1600 SOUTH OCEAN BOULEVARD

SUMMARY OF CHANGES

A-23-067

CURRENTLY PROPOSED EAST ELEVATION

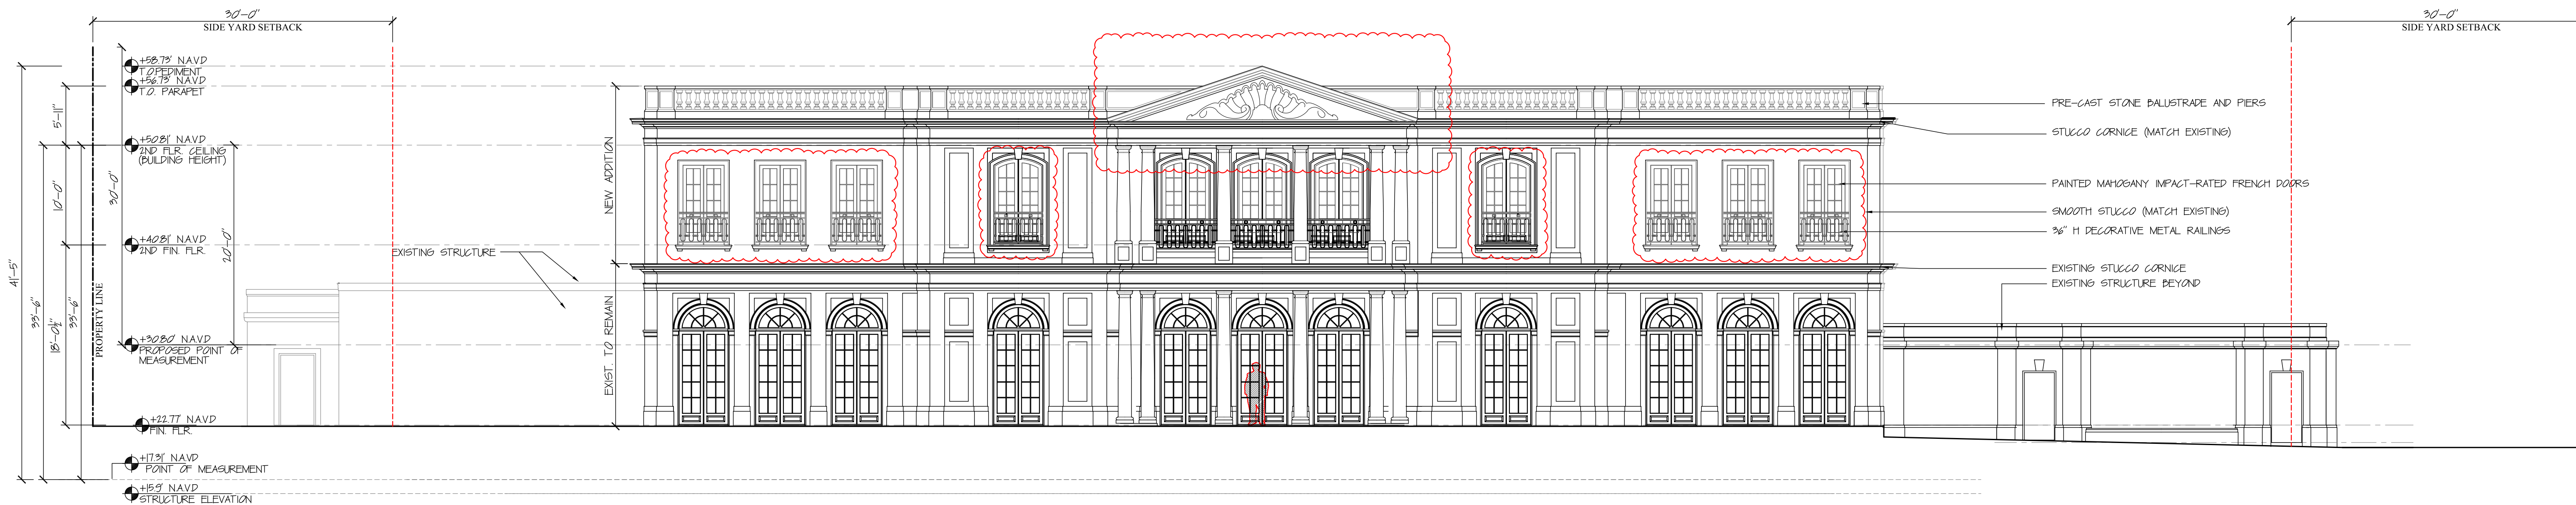
- 1. Reduced slope of pediment.
- 2. Projected columns and pediment to be proud of adjacent walls on East elevation.
- 3. Reduced width of second floor doors on all four elevations.
- 4. Add doors at second floor west elevation for symmetry.
- 5. Add rustication at basement level doors on West elevation.
